# UNITED STATES PATENT AND TRADEMARK OFFICE

APPLICATION NO.	FILING DATE	FIRST NAMED INVENTOR	ATTORNEY DOCKET NO.	CONFIRMATION NO.
10/572,865	06/13/2007	Gary Moore	DEP5178	7275
27777	7590	05/12/2009		
PHILIP S. JOHNSON JOHNSON & JOHNSON ONE JOHNSON & JOHNSON PLAZA NEW BRUNSWICK, NJ 08933-7003			EXAMINER WAGGLE, JR, LARRY E	
			ART UNIT 3775	PAPER NUMBER
			MAIL DATE 05/12/2009	DELIVERY MODE PAPER

<b>Office Action Summary</b>	<b>Application No.</b> 10/572,865	<b>Applicant(s)</b> MOORE ET AL.	
	<b>Examiner</b> Larry E. Waggle, Jr	<b>Art Unit</b> 3775

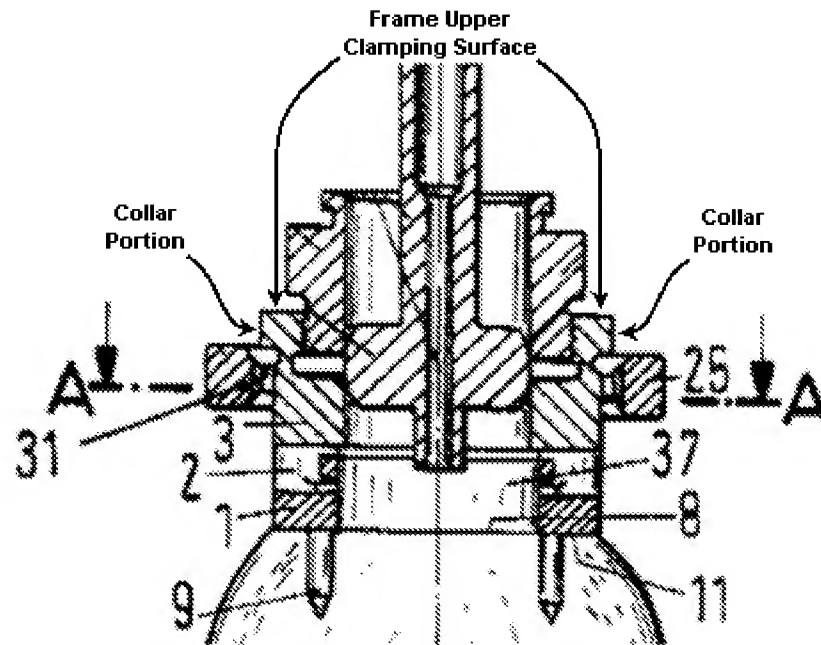
**Claims 1-3 and 8-13** are rejected under 35 U.S.C. 102(b) as being anticipated by Marchione et al. (US Patent 6595999).

Marchione et al. disclose a drill guide assembly comprising a drill guide (6) that includes a sleeve and a bulb (7) at one end of the sleeve (Figure 5), a frame fastenable (via 9) to a bone that includes a housing (3) which defines a recess (32) in which the drill guide bulb can be received with the drill guide sleeve extending out of the recess in a direction away from the bone, so that the angular orientation ( $\alpha$ , Figure 5) of the drill guide sleeve relative to the housing can be adjusted by movement of the bulb within the recess (column 2, lines 37-41), a clamp (5) comprising a lower pair of clamping surfaces provided by the drill guide bulb and the internal wall of the recess (5, 7 and 32 in Figure 10) respectively facing generally towards the patient's bone, an upper pair of clamping

surfaces on the drill guide and on a hollow collar portion of the housing respectively facing generally away from the patient's bone and being spaced apart from the bulb along the drill guide sleeve (see annotated Figure below), arranged so that the drill guide can be locked against angular adjustment by engagement between the frame clamping surfaces and the drill guide clamping surfaces of each of the lower and upper pairs; an actuator (29); and an alignment stylus (13) connected to the drill guide to move with the drill guide relative to the frame including a first limb that is directed towards the bone, to facilitate assessment of the alignment of the drill guide sleeve relative to anatomical features of the bone, wherein the stylus can be moved rotatably around the drill guide sleeve, the stylus can be moved around the drill guide sleeve while the clamp is engaged to prevent angular movement of the drill guide relative to the frame, and wherein the stylus includes a second limb extending from the first limb in a direction generally towards the axis of the assembly (Figure 8 and column 5, lines 25-60), and the frame provides a platform (top of 2, displacement element in Figure 9) that defines a plane that is spaced apart from the bone and an axis of the assembly (along 14) that extends perpendicular (column 5, lines 13-19) to the said plane, and wherein the drill guide is mounted on the platform so that it can be translated relative to the frame generally in the plane of the platform which includes a lock (25), and wherein the clamp and the lock can be engaged and disengaged independently of one another (column 4, lines 11-57).
